ADDENDUM NO. 1

TO: PLANS AND SPECIFICATIONS FOR STATE OF MISSOURI

**Renovate Lobby and Restrooms 1st and 2nd Floor
Howerton State office Building
Jefferson City, Missouri
PROJECT NO.: O2339-01**

A-205

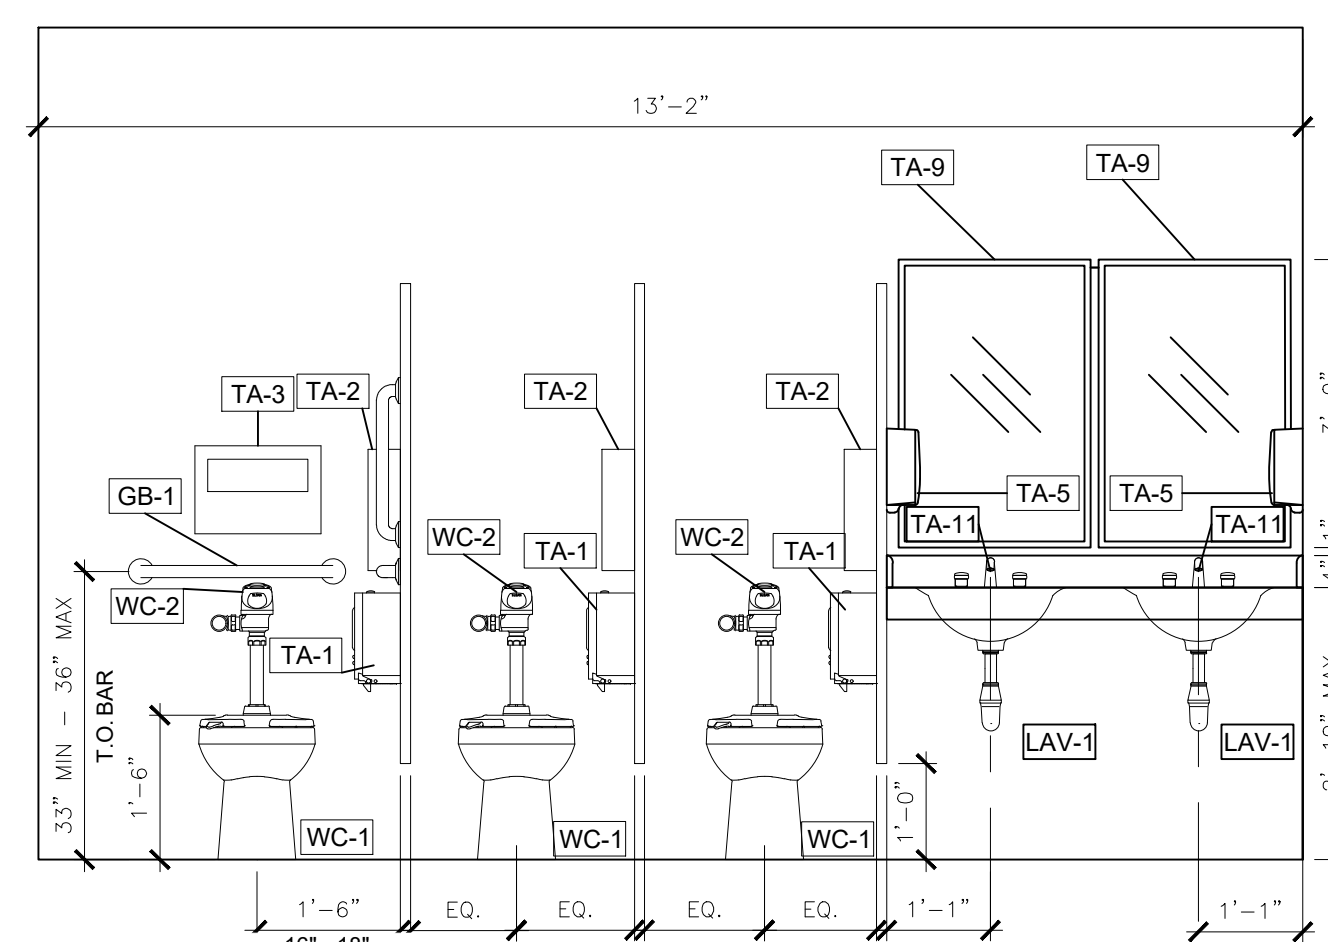
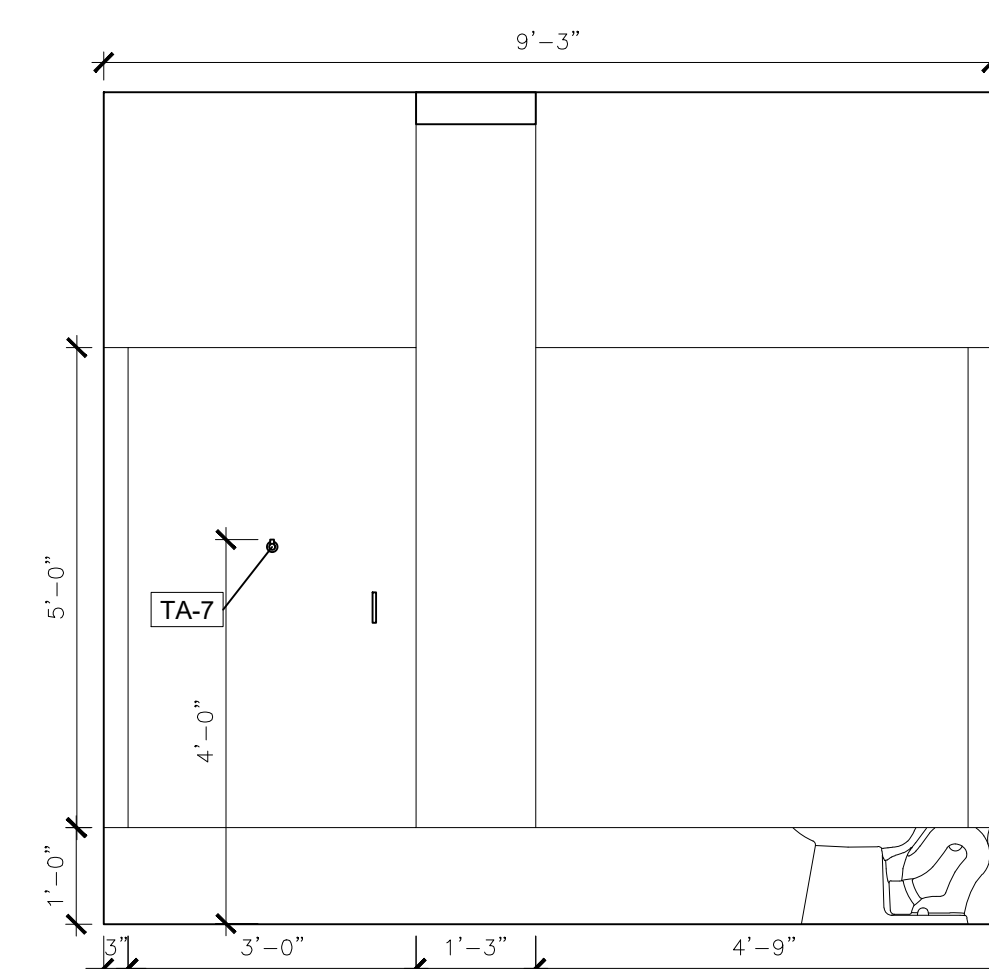
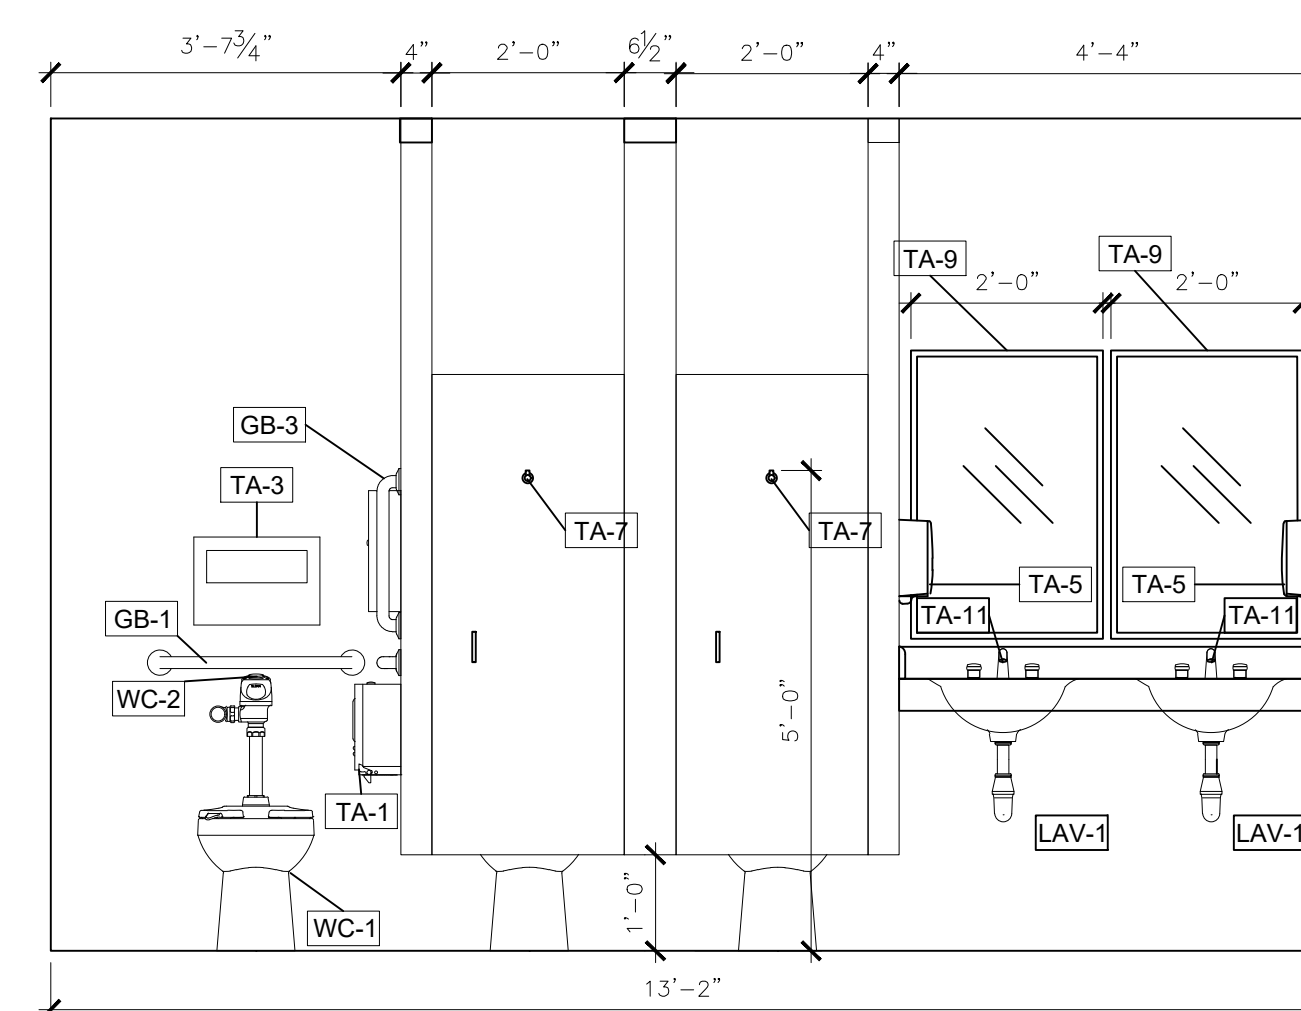
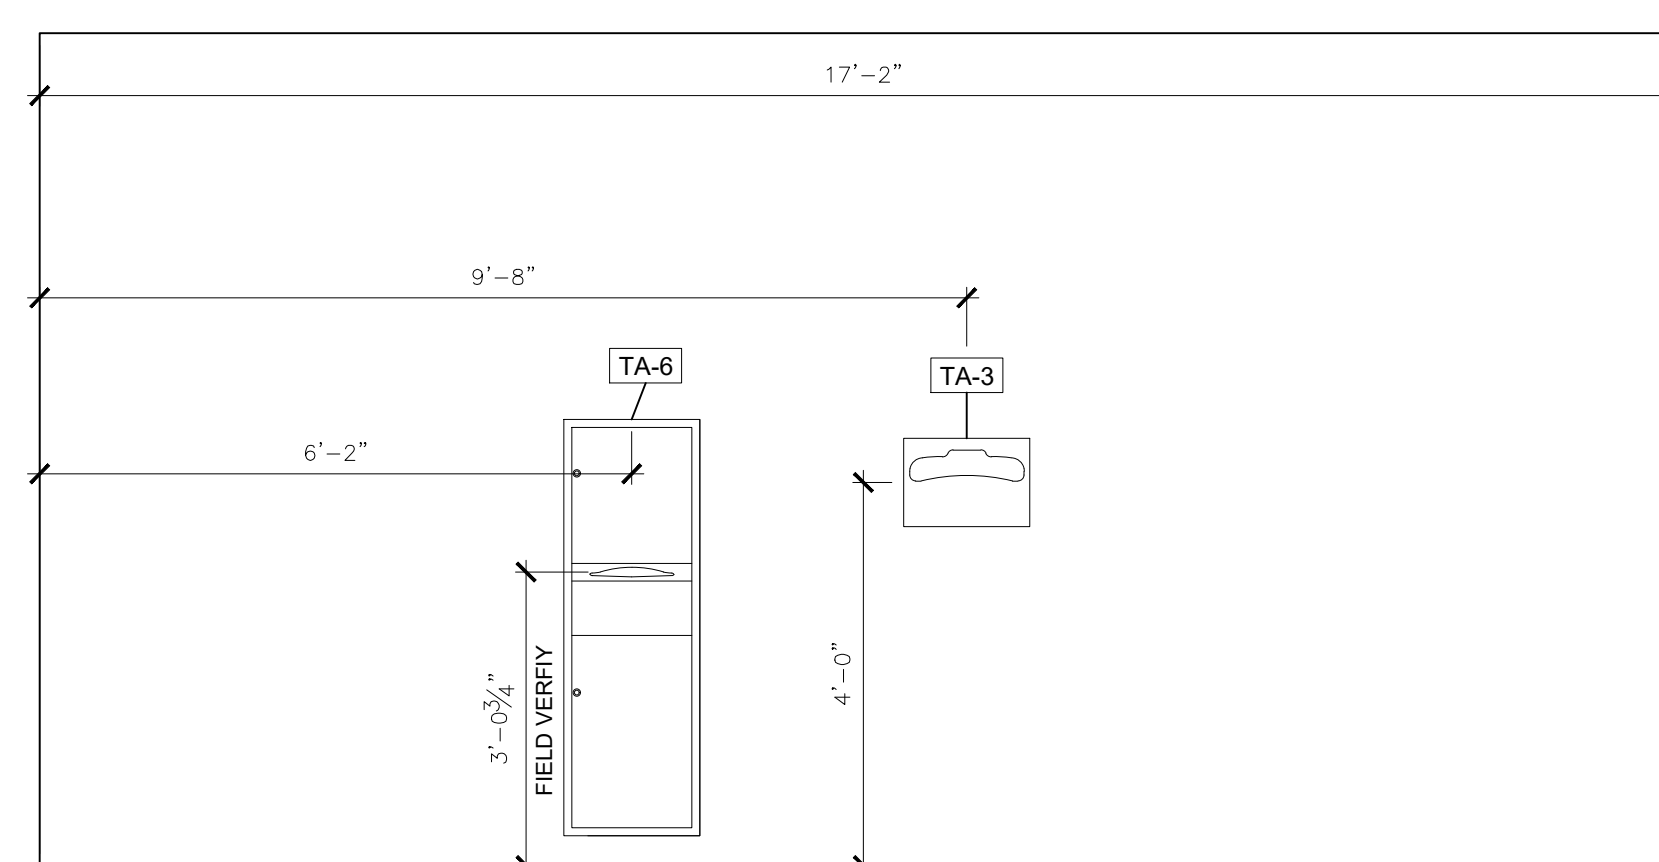
A-205

- 1. Restroom Finish Schedule: Clarifications per mark.
 - GB-1 Changed grab bar to 36" grab bar.
 - GB-2 Changed grab bar to 42" grab bar.
 - GB-3 Changed grab bar to 18" grab bar.
 - TA-7 Changed coat hook to coat hooks (to be installed inside of stalls)
 - TA-8 Changed mirror to 24" x 72" mirror.
 - TA-9 Changed mirror to 24" x 36" mirror.
- 2. Changed note from: See A-601 for full fixture schedule to See sheets A-104 - A-105 for full fixture schedules.

A-206

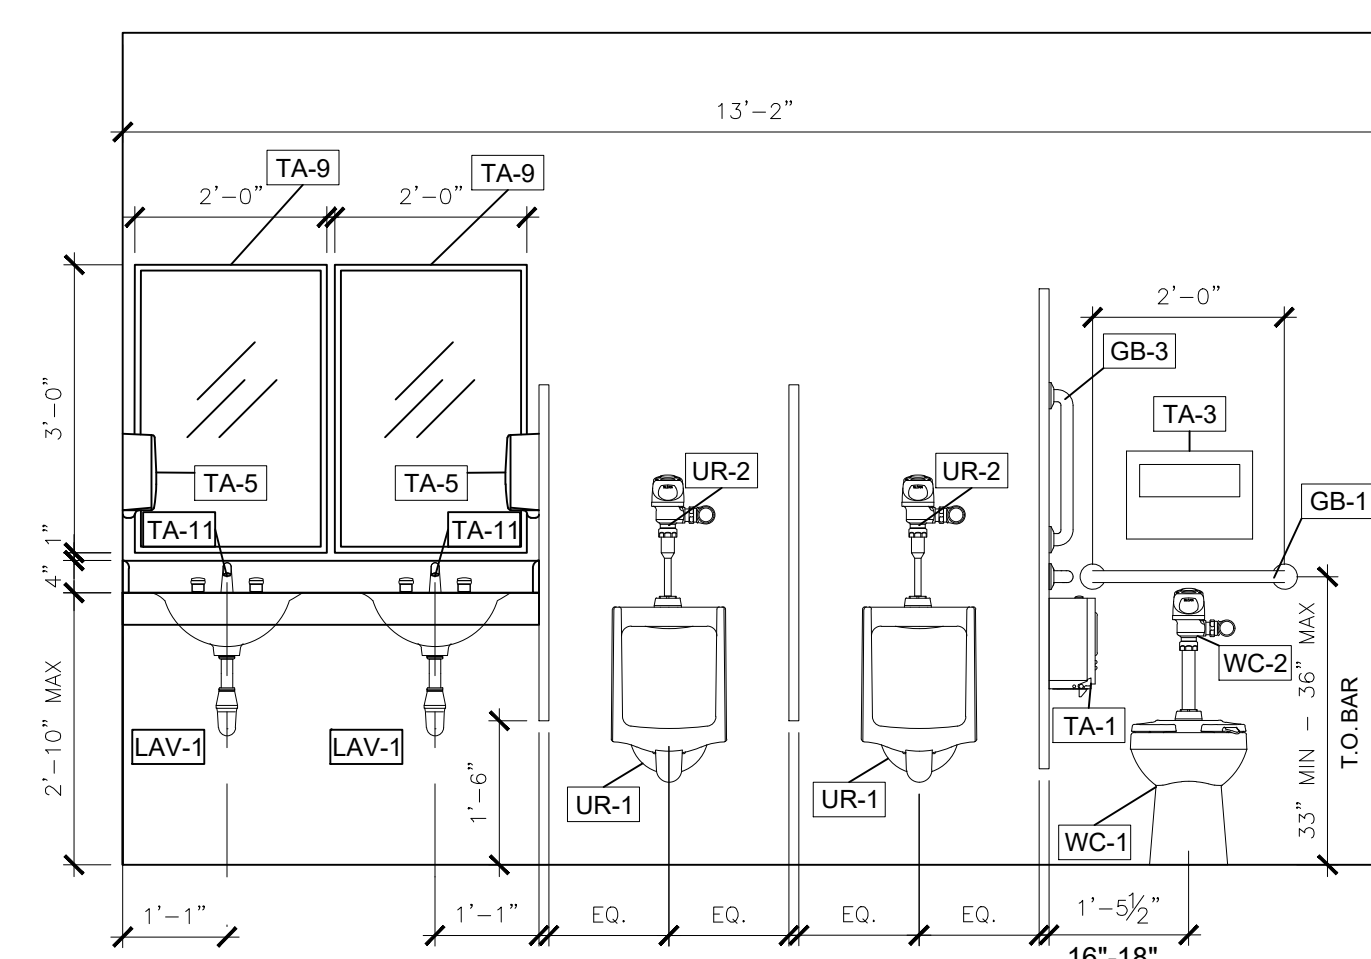
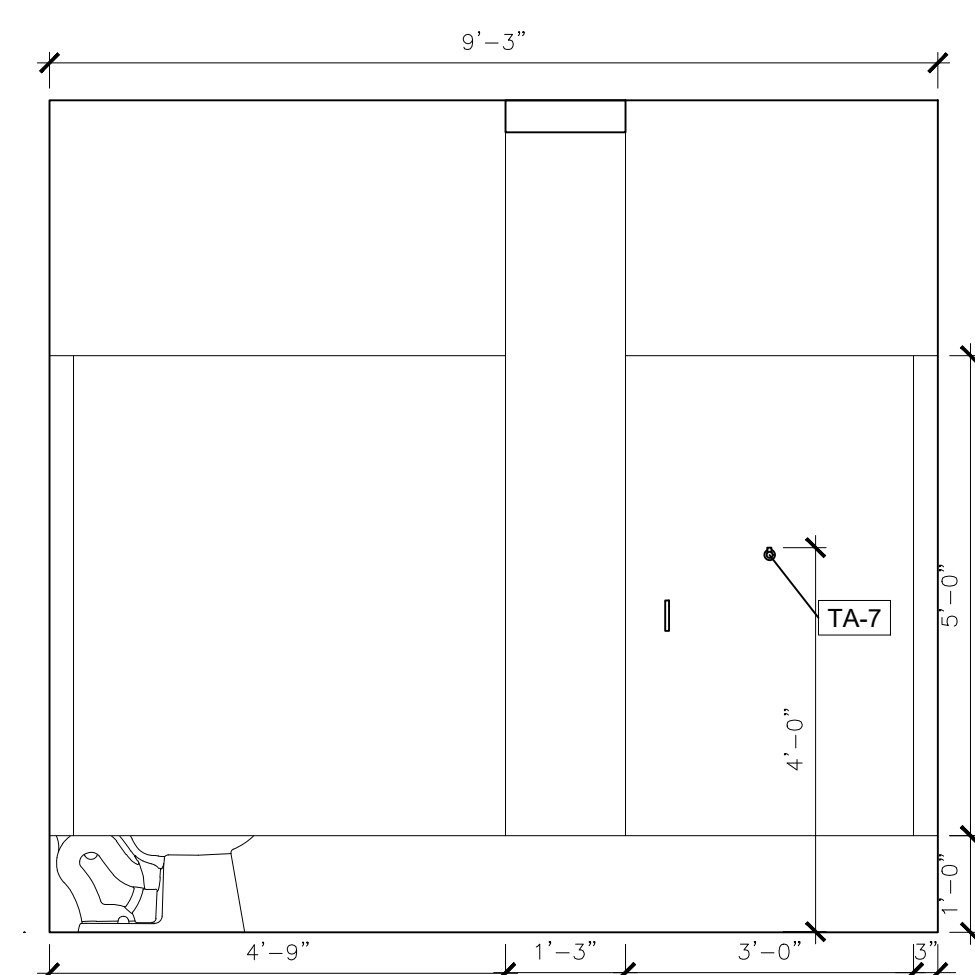
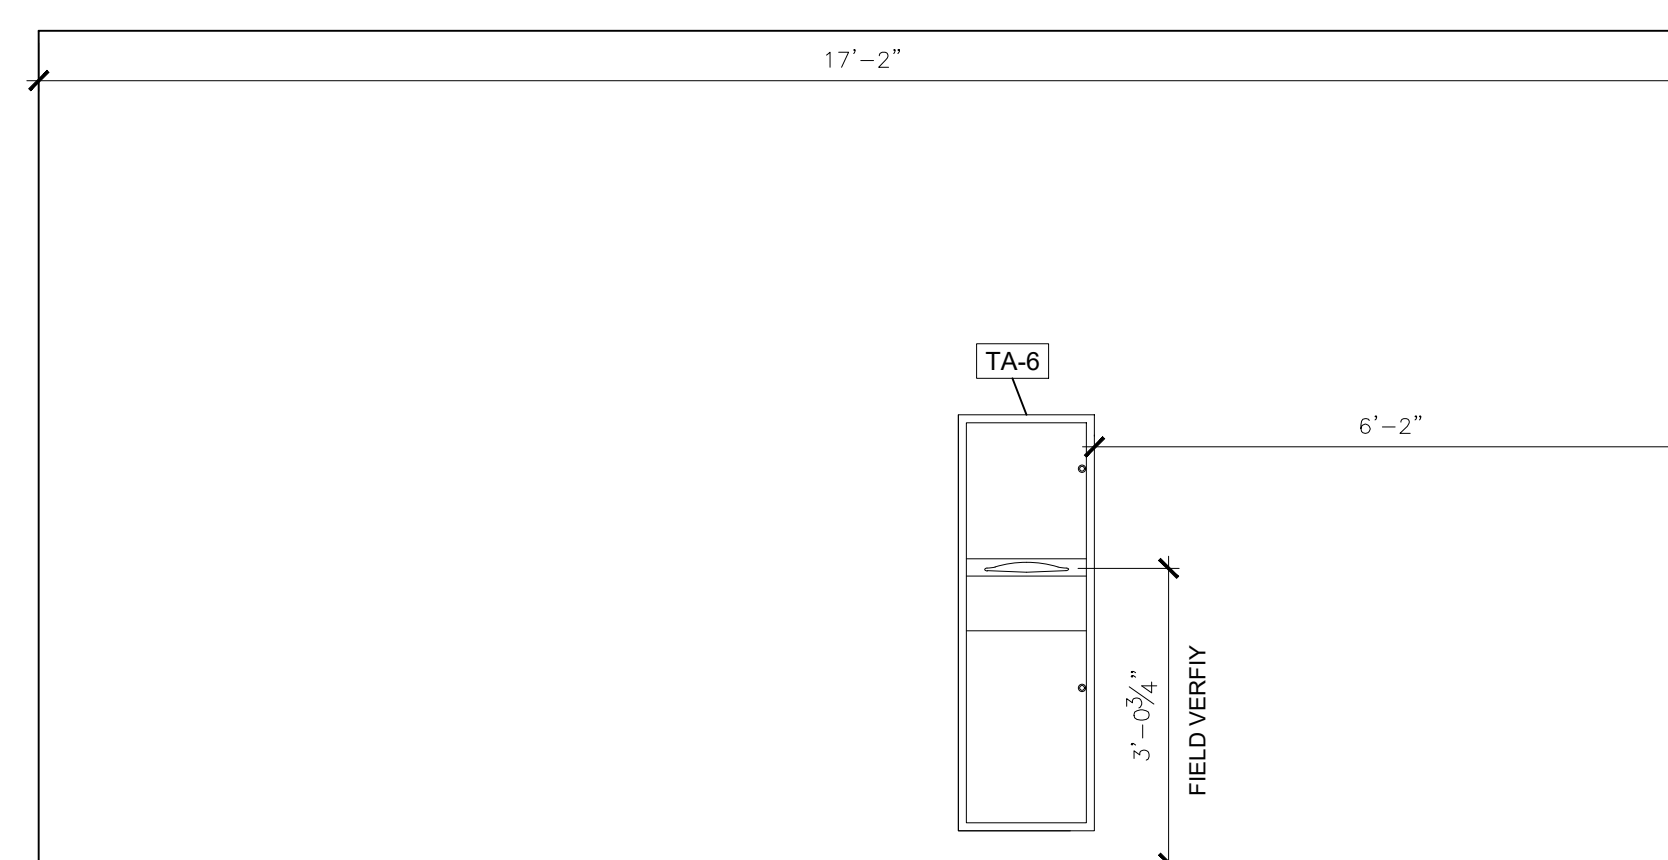
A-206

1. Restroom Finish Schedule: Clarifications per mark.
 - GB-1 Changed grab bar to 36" grab bar.
 - GB-2 Changed grab bar to 42" grab bar.
 - GB-3 Changed grab bar to 18" grab bar.
 - TA-7 Changed coat hook to coat hooks (to be installed inside of stalls)
 - TA-8 Changed mirror to 24" x 72" mirror.
 - TA-9 Changed mirror to 24" x 36" mirror.
2. Changed note from: See A-601 for full fixture schedule to See sheets A-104 - A-105 for full fixture schedules.
